Title: Torque / Washer Check L/H Lower Engine Mount Rotax 915 iS		
AG-SB-2023-04-B-EN	Effective Date: 09.10.2023	Compliance Category:
Applicability		A - MANDATORY B - RECOMMENDED C - OPTIONAL
Aircraft type & model: All aircraft with a Rotax 915 iS engine and a fixed nut on the left lower engine mount	Affected Serial number(s): All aircraft	
The maintenance manual to be referenced is this stated or subsequent issue.		As per AutoGyro website
This form is the response from AutoGyro GmbH either against a problem found in the product in service requiring a containment or rectification action, or as service information for aircraft modification incorporation. For help, contact airworthiness@auto-gyro.com .

Bolt with Nord-Lock washer

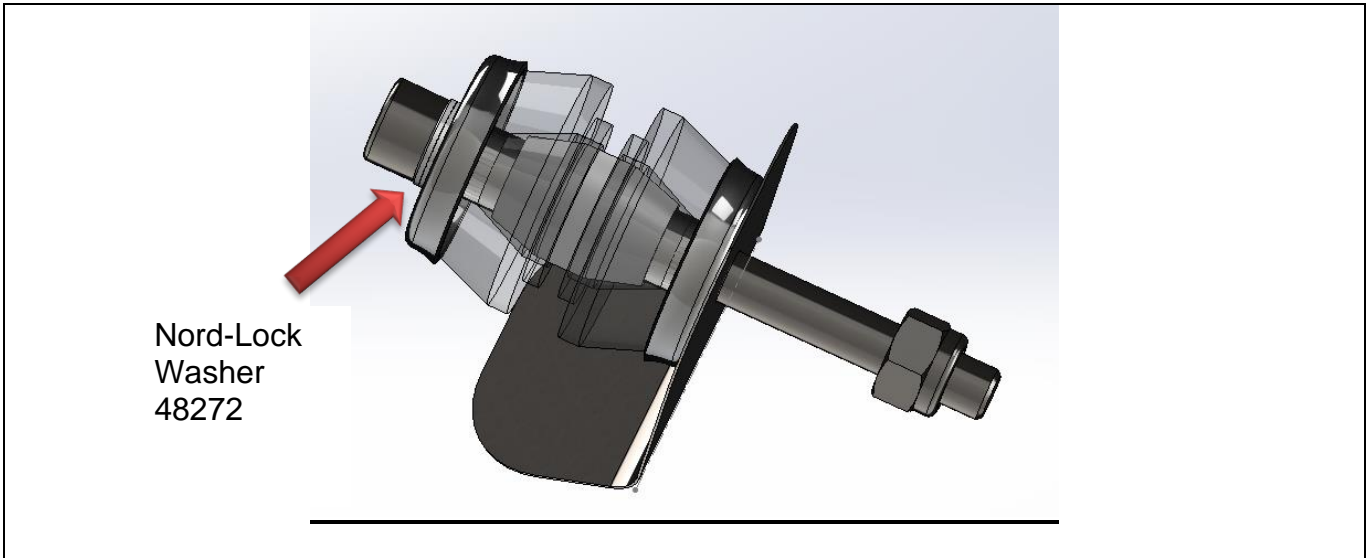
Rotax has factory fitted a nut to the turbocharger plate. AutoGyro now use Nord-Lock washer (PN 48272) in combination with this nut. This washer is only required for Rotax 915 iS engines with a fixed nut. Otherwise, the all-metal nut is used as before. Observe modified tightening torque 56 Nm.

If the aircraft is NOT fitted with a Nord-Lock washer on the lower left hand engine mount, carefully loosen the nut and remove the bolt. Support the engine with a crane or similar if necessary. Install the Nord-Lock washer (convex side facing bolt head) and put the bolt back in, release the engine from the crane if this has been done and torque the bolt with 56Nm.
